AFFIDAVIT OF CORRECTION

To correct certain dimensions of Lots 2 and 4, and Southport Parkway Right-of-way and also Curve 1 in the Center-line Curve Table, Southport East (Lots 1 thru 16 inclusive and Outlot "A"), a subdivision located in the East 1/2 of Section 18, and also in the NW 1/4 of Section 17, all located in Township 14 North, Range 12 East of the 6th P.M., Sarpy County, Nebraska.

AFFIDAVIT OF CORRECTION  
LOTS 2 AND 4, AND SOUTHPORT PARKWAY RIGHT-OF-WAY,  
SOUTHPORT EAST  
(LOTS 1 THRU 16 INCLUSIVE AND OUTLOT "A")  
SARPY COUNTY, NEBRASKA

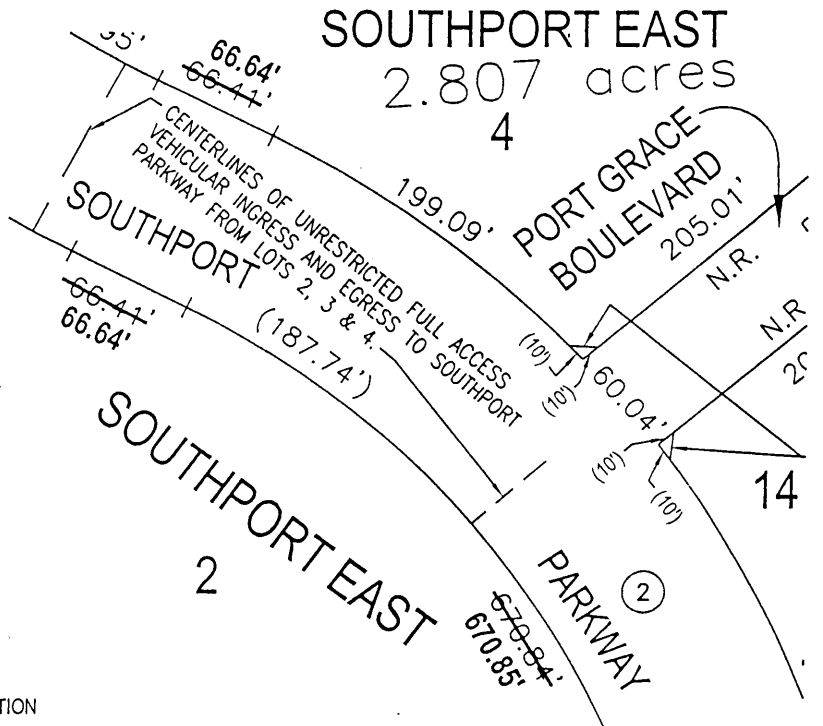
- The Northeastly line of said Lot 2 to read 66.64 feet instead of 66.41 feet.
- The Southwestly Right-of-way line of Southport Parkway to read 66.64 feet instead of 66.41 feet.
- The Northeastly line of said Lot 2 to read 670.85 feet instead of 670.84 feet.
- The Southwestly Right-of-way line of said Southport Parkway to read 670.85 feet instead of 670.84 feet.
- The Southwestly line of said Lot 4 to read 66.64 feet instead of 66.41 feet.
- The Northeastly Right-of-way line of said Southport Parkway to read 66.64 feet instead of 66.41 feet.
- The Curve 1 in said Center-line Curve Table to read Radius - 549.50 feet, Length - 316.08 feet, Tangent - 162.55 feet, Delta - 32°57'26" instead of Radius - 549.32 feet, Length - 315.79 feet, Tangent - 162.39 feet, Delta - 32°56'15".

CURVE 1 549.50' 316.08' 162.55' 32°57'26"
